ECE/TRANS/WP.29/GRE/2006/10
26 January 2006

PROPOSAL FOR DRAFT AMENDMENTS TO REGULATION No. 112

(Headlamps emitting an asymmetrical passing beam)

Transmitted by the expert from the Working Party "Brussels 1952" (GTB)

Figure 1

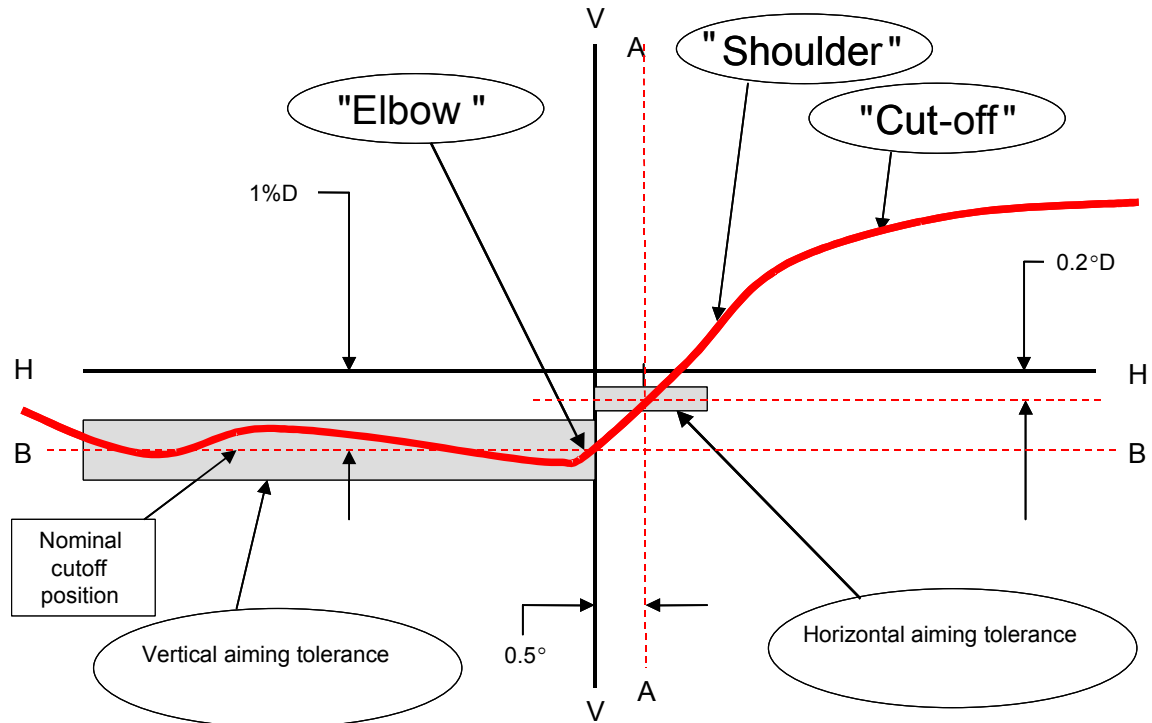
"6.2.1. **The luminous intensity distribution of the passing beam headlamp shall incorporate a "cut-off" (see Figure 1 below), which enables the headlamp to be adjusted correctly for the photometric measurements and for the aiming on the vehicle.**

The "cut-off" shall provide:

- (a) **For right hand traffic beams:**
 - (i) **a straight "horizontal part" towards the left;**
 - (ii) **a raised "elbow - shoulder" part towards the right.**
- (b) **For left hand traffic beams:**
 - (i) **a straight "horizontal part" towards the right;**
 - (ii) **a raised "elbow - shoulder" part towards the left.**

In each case the "elbow-shoulder" part shall have a sharp edge.

6.2.2. **The headlamp shall be visually aimed by means of the "cut-off" (see Figure 1 above) as follows:**

6.2.2.1. **for vertical adjustment: the horizontal part of the "cut-off" is moved upward from below line B and adjusted to its nominal position one per cent (25 cm) below the H-H line;**

6.2.2.2. for horizontal adjustment: the "elbow – shoulder" part of the "cut-off" shall be moved:

- for right hand traffic from right to left and shall be horizontally positioned after its movement so that:
- above the line $0.2^\circ D$ its "shoulder" shall not exceed the line A to the left and
- on the the line $0.2^\circ D$ or below its "shoulder" should cross the line A and
- the kink of the "elbow" should be primarily on the V-V line;

- **above the line 0.2° D its "shoulder" shall not exceed the line A to the right and**
- **on the the line 0.2° D or below its "shoulder" should cross the line A and**
- **the kink of "elbow" should be primarily on the V-V line.**

Figure 1: Measurement of "cut-off" quality

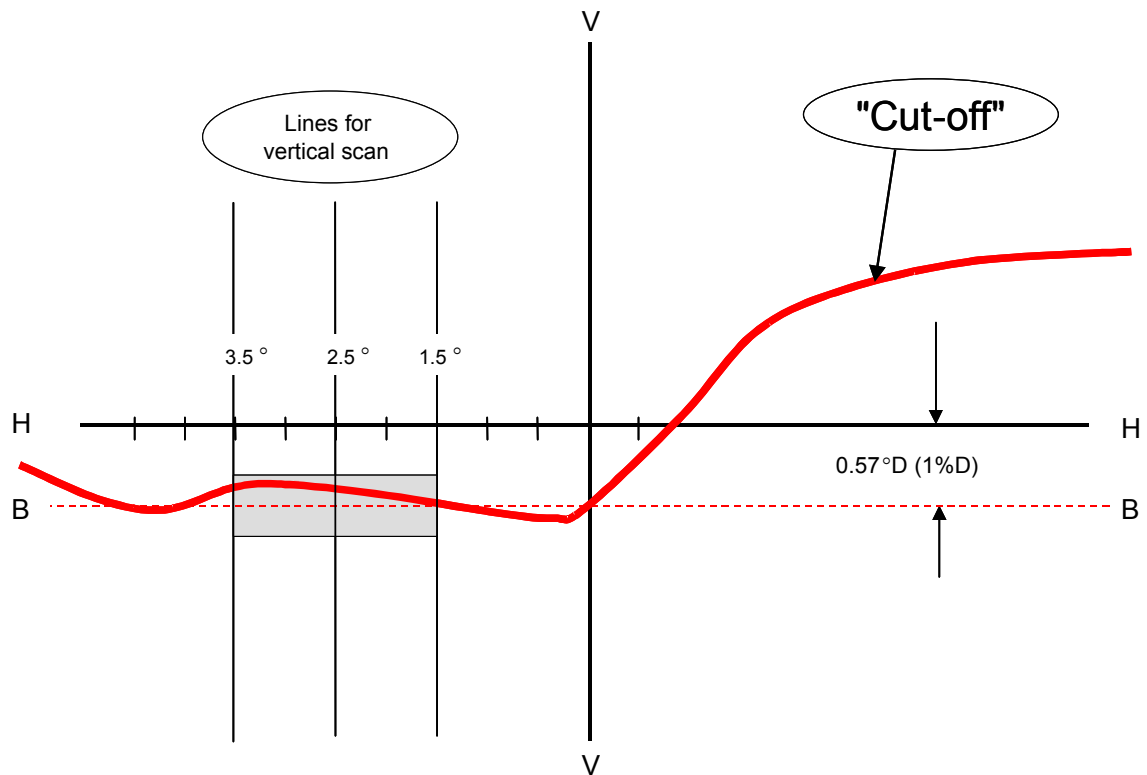
The part of the horizontal "cut-off" that serves for vertical adjustment shall be horizontal between 1.5° and 3.5° from the V-V line (see Figure 1 below).

- The inflection points of the "cut-off" gradient at the vertical lines at 1.5°, 2.5° and 3.5° shall be determined by the equation:

$$(d^2 (\log E) / d\beta^2 = 0).$$

- The maximum vertical distance between the inflection points determined shall not exceed 0.2 °.

Figure 2: Instrumental vertical and horizontal adjustment- horizontal line scan method

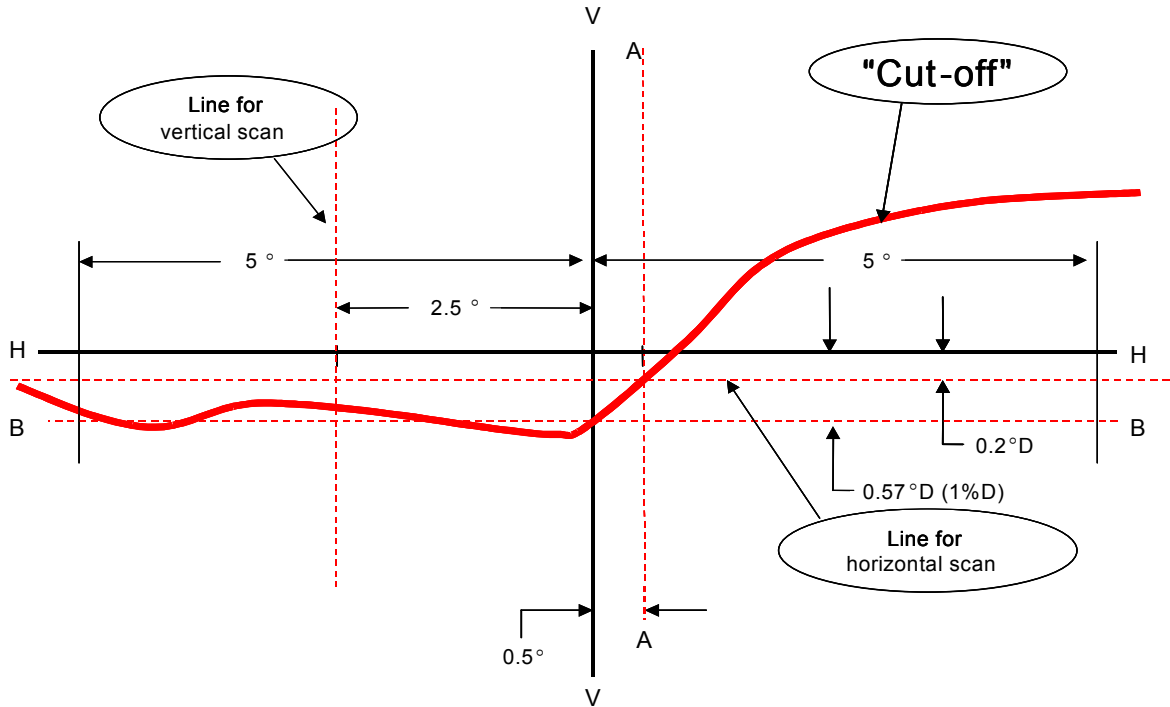
Moving upward from below the line B (see Figure 2 below), a vertical scan is carried out through the horizontal part of the "cut-off" at 2.5° from V-V. The inflection point (where $d^2(\log E) / dv^2 = 0$) is determined and positioned on the line B situated one per cent below H-H.

(a) The "0.2 D line" method (see Figure 2 below).

A single horizontal line at 0.2° D shall be scanned from 5° left to 5° right after the lamp has been aimed vertically. The maximum gradient "G"

determined using the formula $G = (\log E_{\beta} - \log E_{(\beta + 0.1^{\circ})})$ where β is the horizontal position in degrees, shall not be less than 0.08.

The inflection point found on the 0.2 D line shall be positioned on the line A.

Figure 3: Instrumental vertical and horizontal adjustment-three line scan method

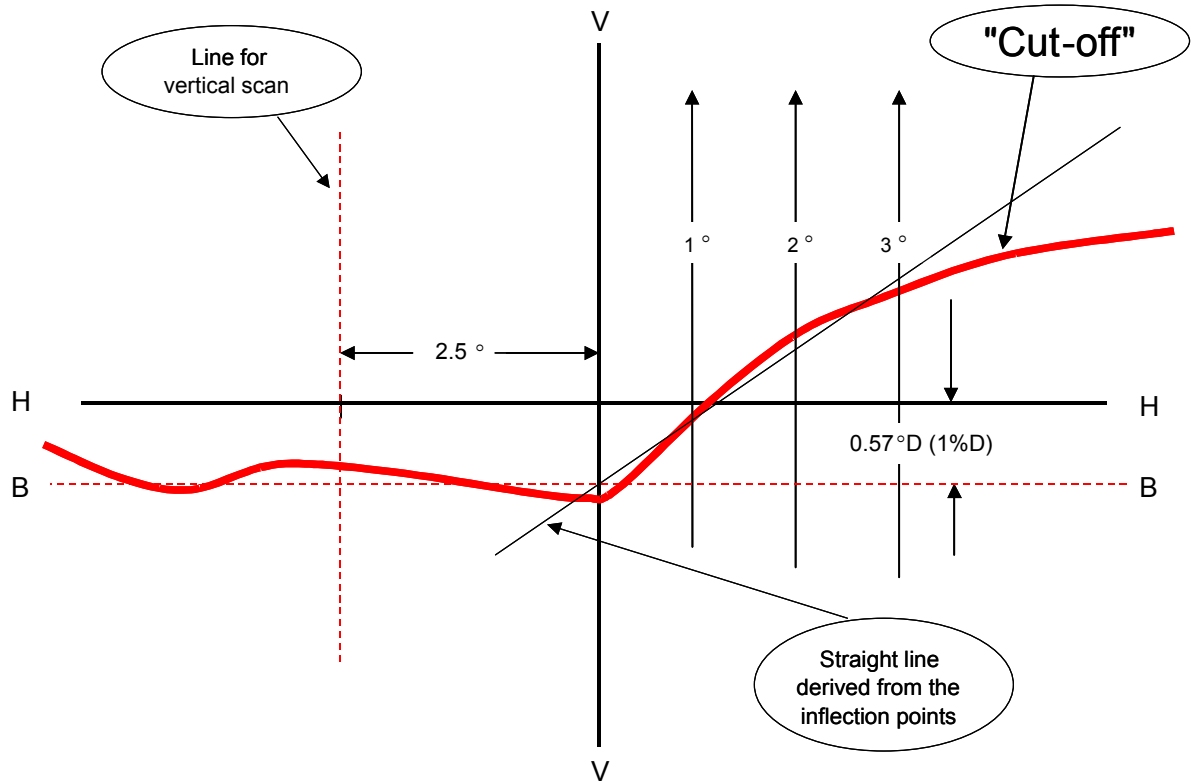
(b) The "3 line" method (see Figure 3 below)

Three vertical lines shall be scanned from 2° D to 2° U at 1°R, 2°R, and 3°R after the lamp has been aimed vertically. The respective maximum gradients "G" determined using the formula:

$$G = (\log E_{\beta} - \log E_{(\beta + 0.1^{\circ})})$$

where β is the vertical position in degrees, shall not be less than 0.08. The inflection points found on the three lines shall be used to derive a straight line. The intersection of this line and the line B found while performing vertical aim shall be placed on the V line.
